**Re: Response to Second Review of Nobscot Scout Reservation Trail Project
1 Nobscot Road, Sudbury, MA**

Howard Stein Hudson (HSH) has prepared a response to the Sudbury Conservation Commission comments dated November 2, 2022 and offers the following responses including submitting supplemental information:

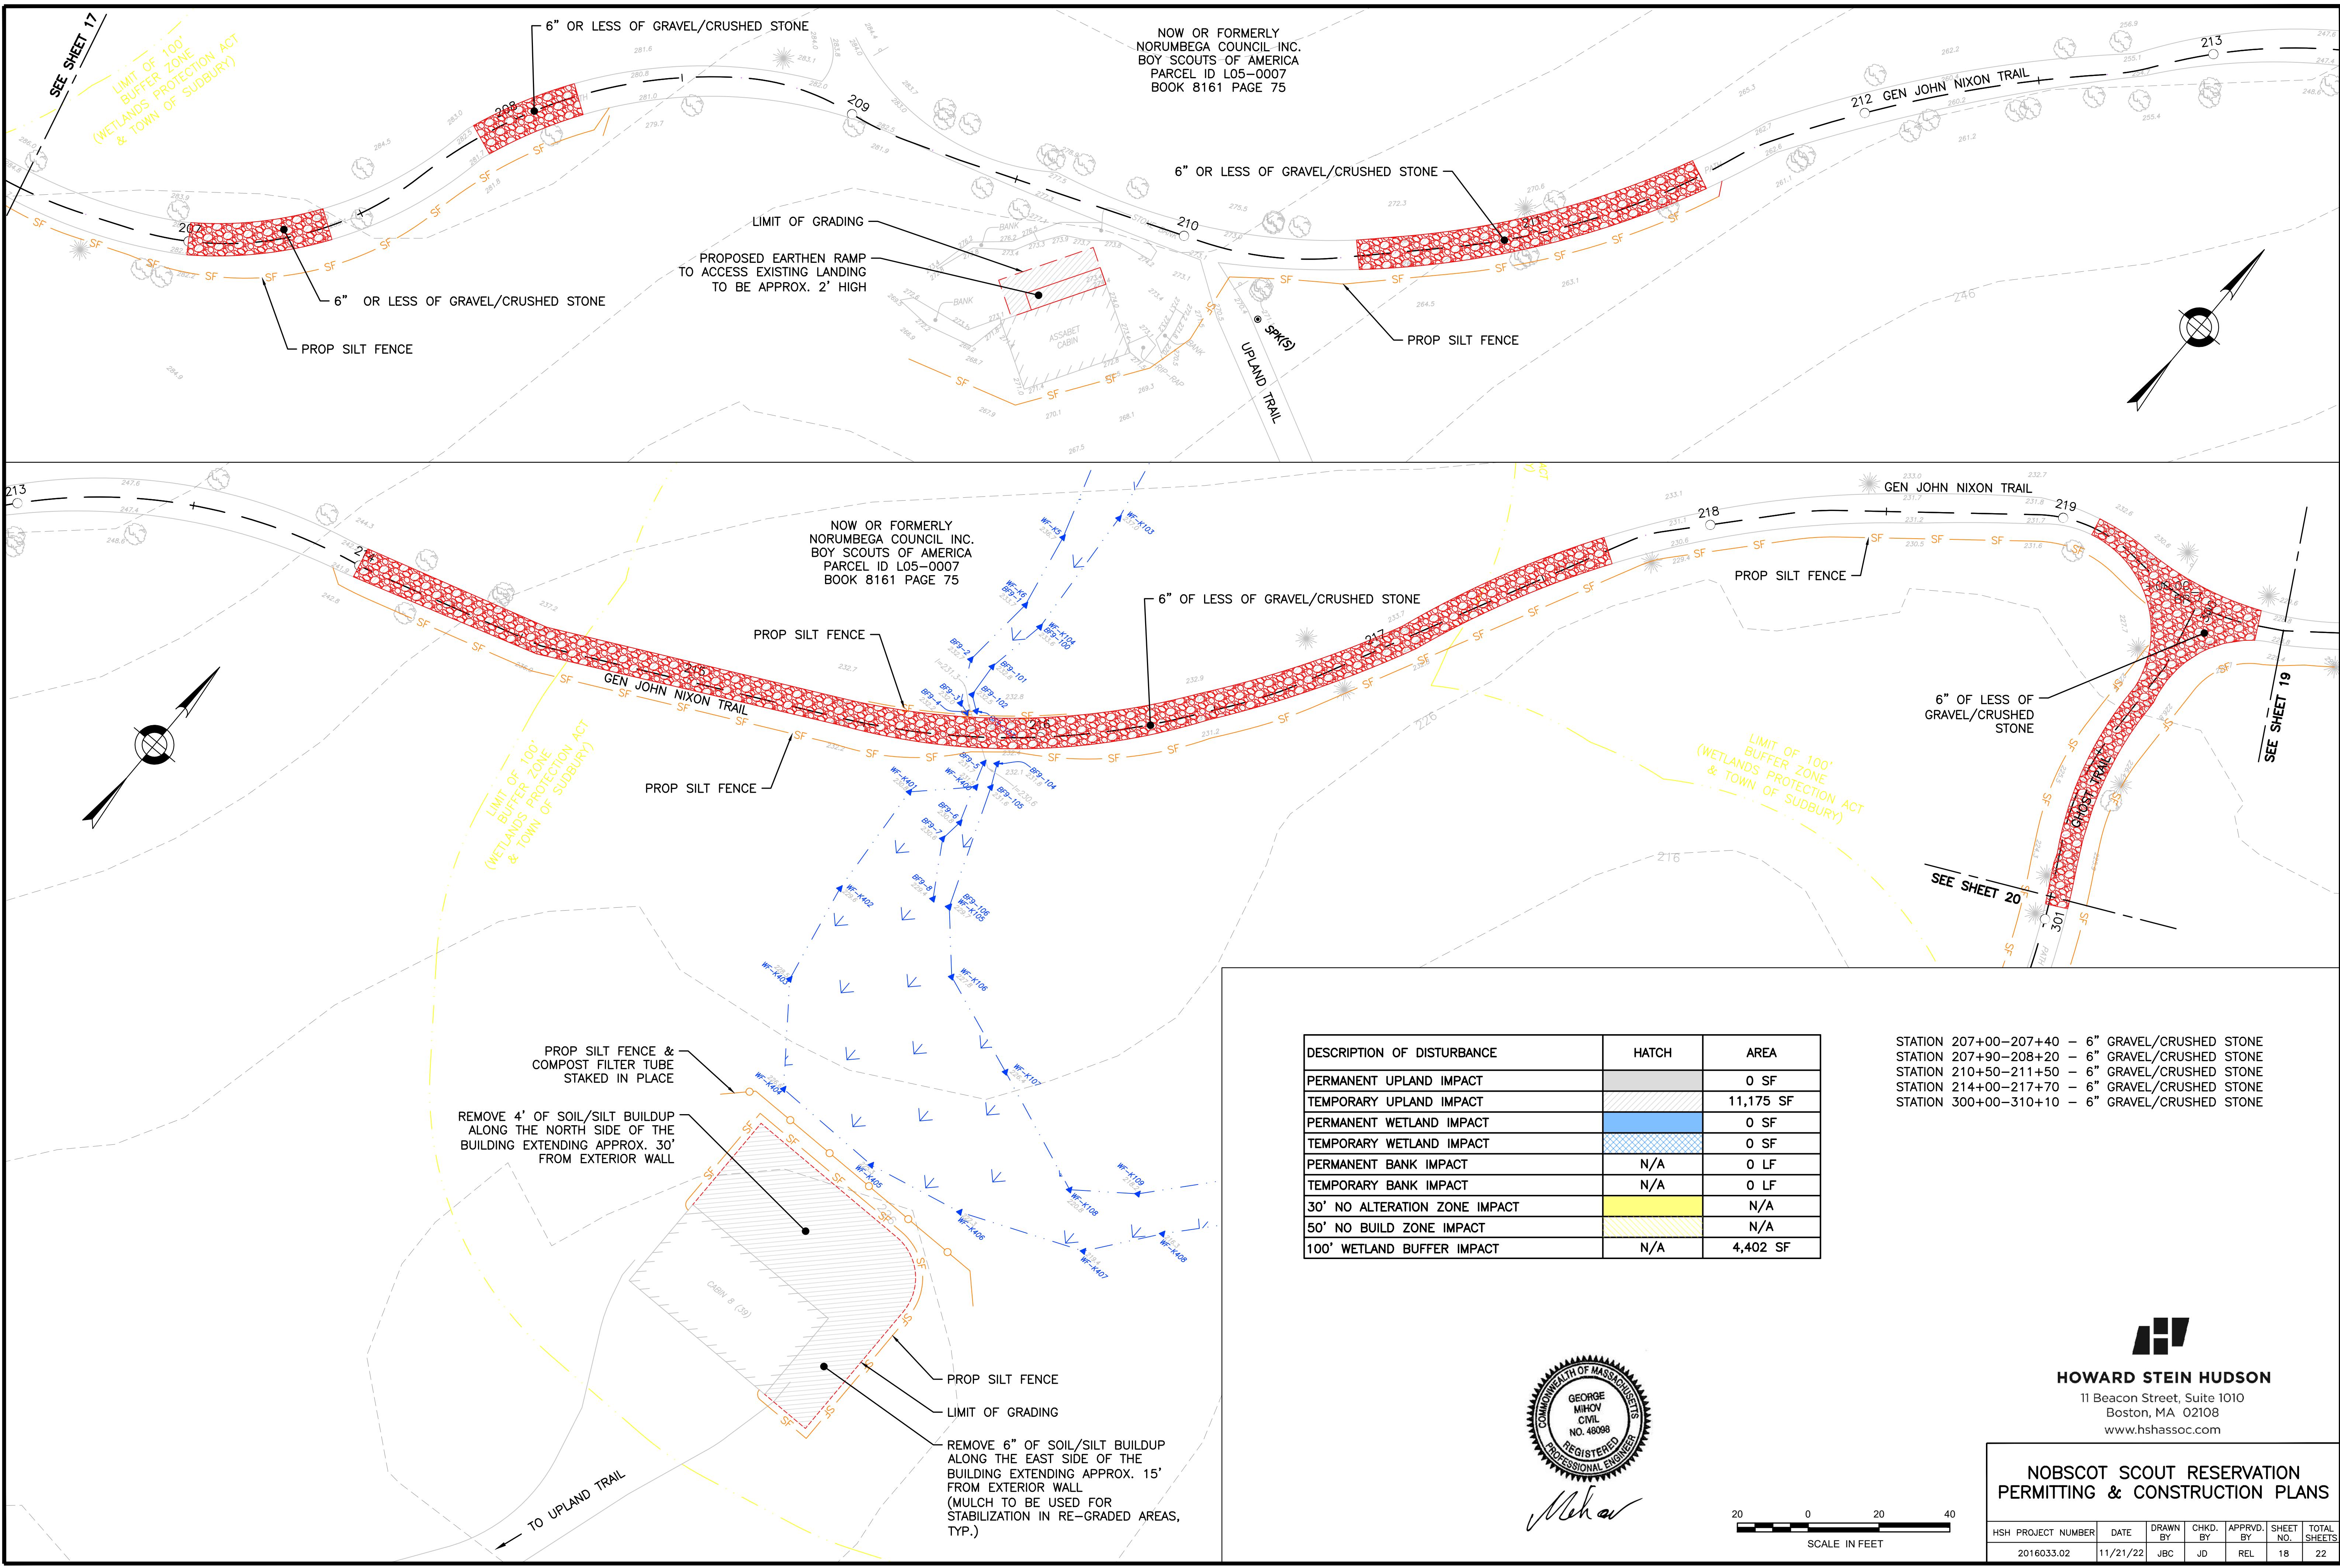
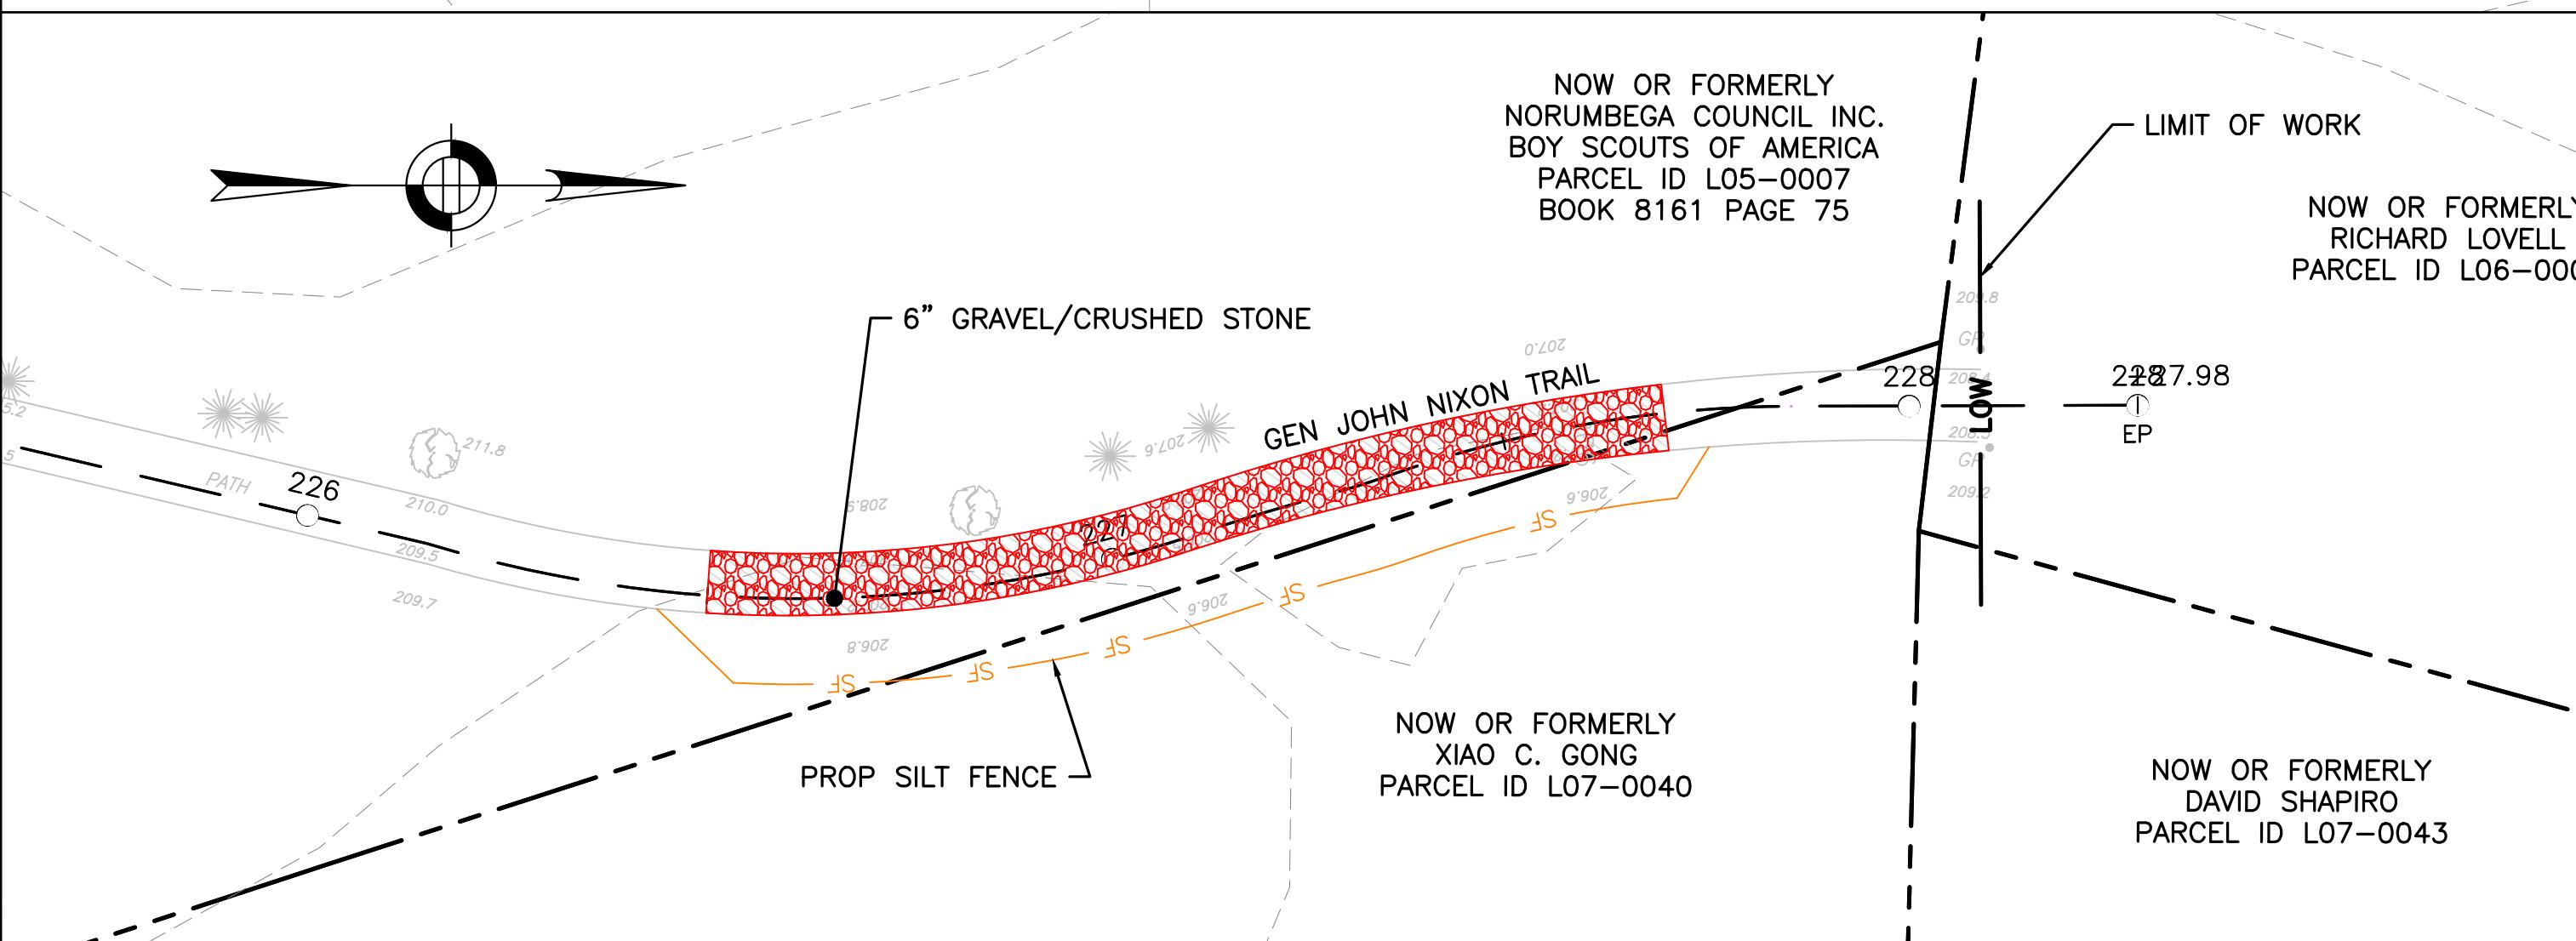
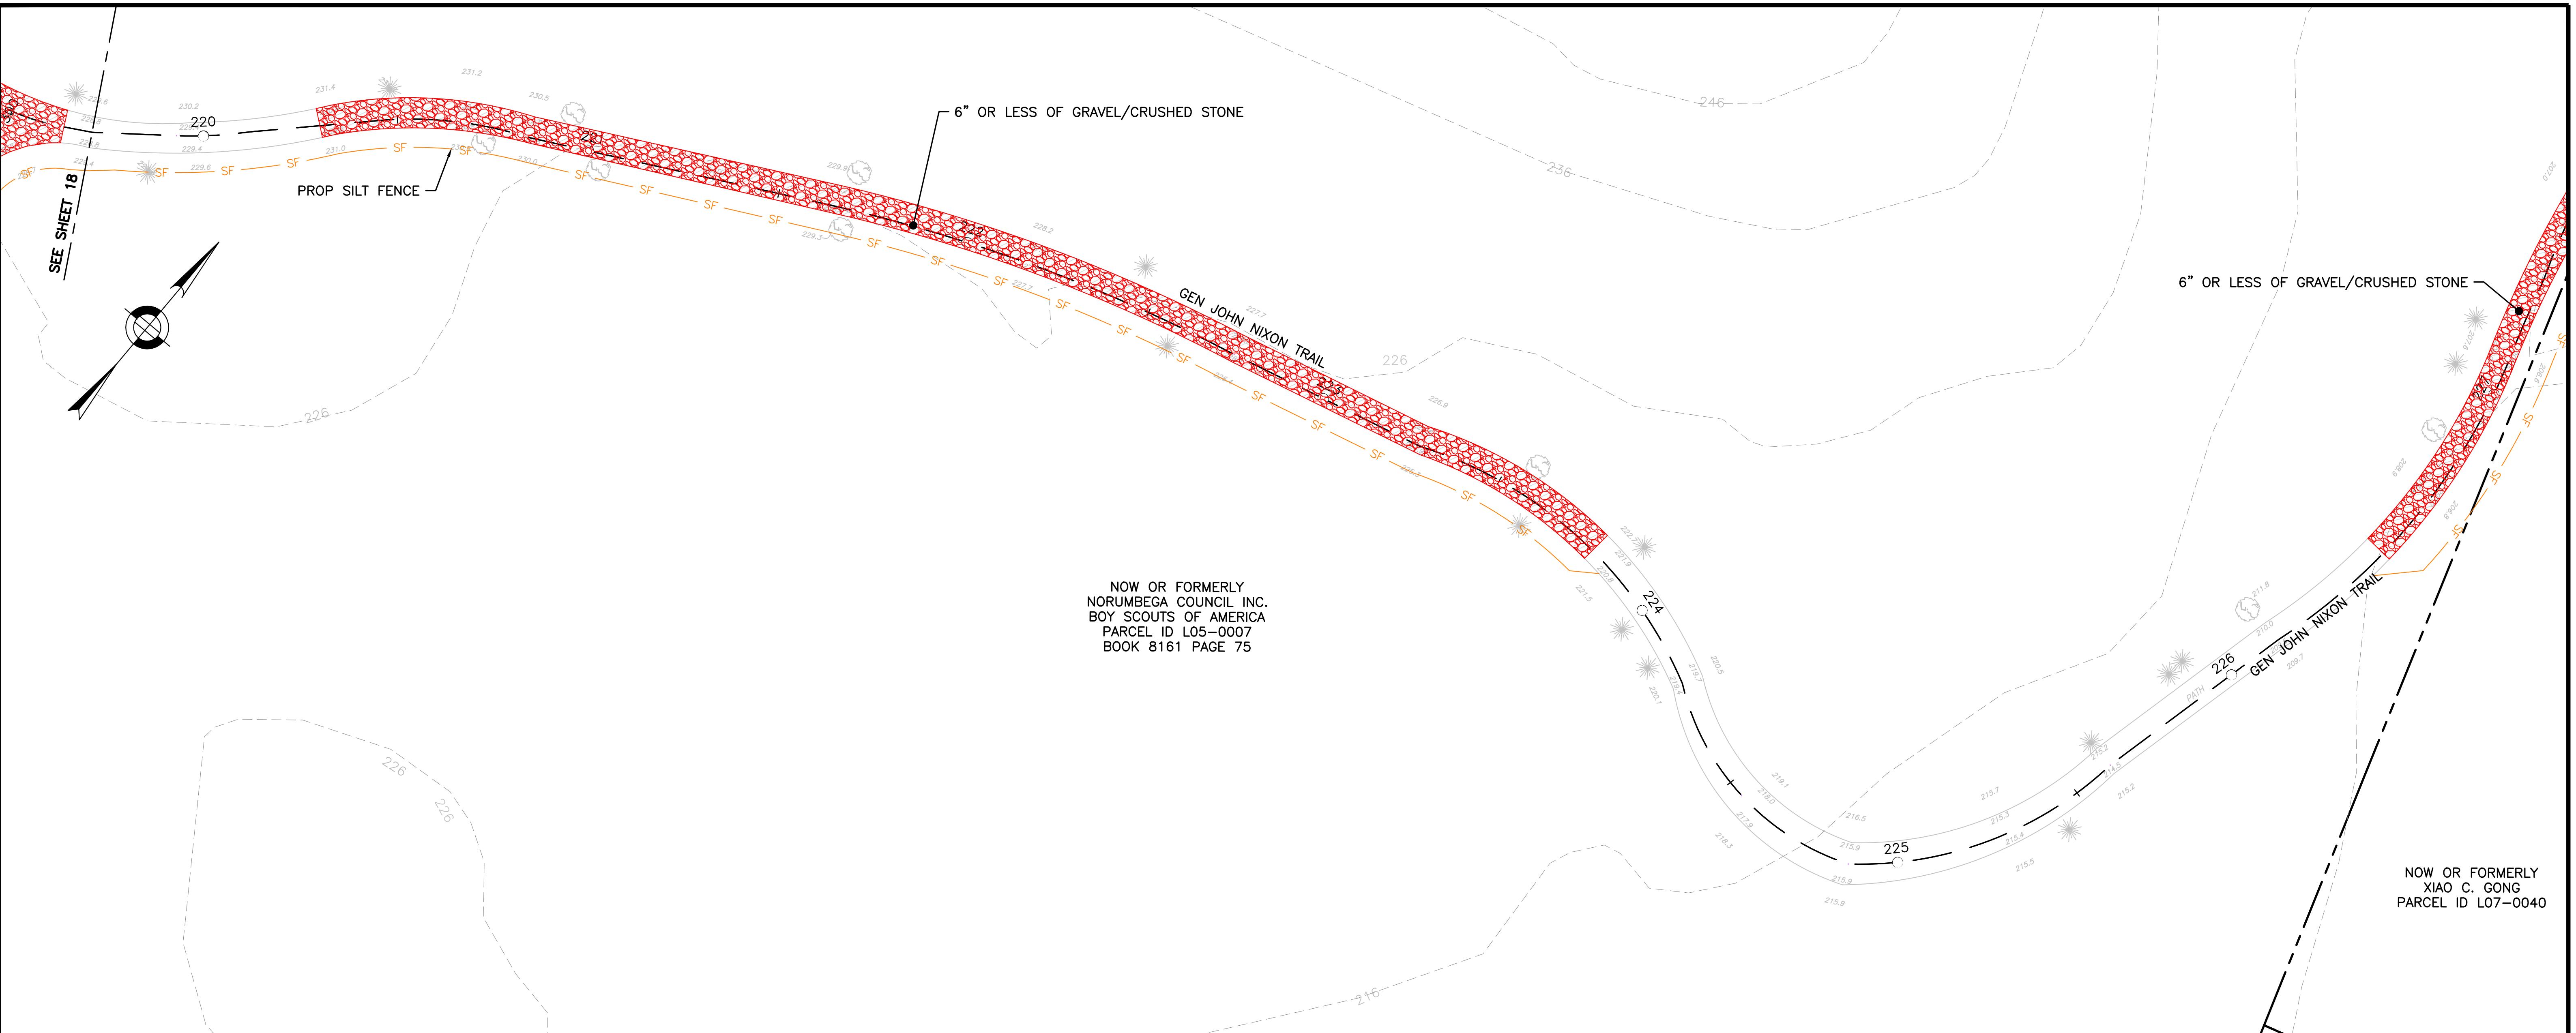
Comment 12: *The applicant should clarify silt fence installation around the cabins, such as shown on sheet 18 for Cabin 8. This is located very close to wetlands and there is no way to access the excavation area whereas it is completely surrounded by silt fence. There is also no access shown to this cabin nor protection of the wetland located between the trail and the cabin.*

Response: **The enclosed silt fence around the cabin is to create a work zone to provide a continuous barrier to keep turtles from entering. A section of fence will be removed to allow access. An additional line of silt fence has been added between the wetland and the work zone. The access trail to the cabin 8 have also been added.**
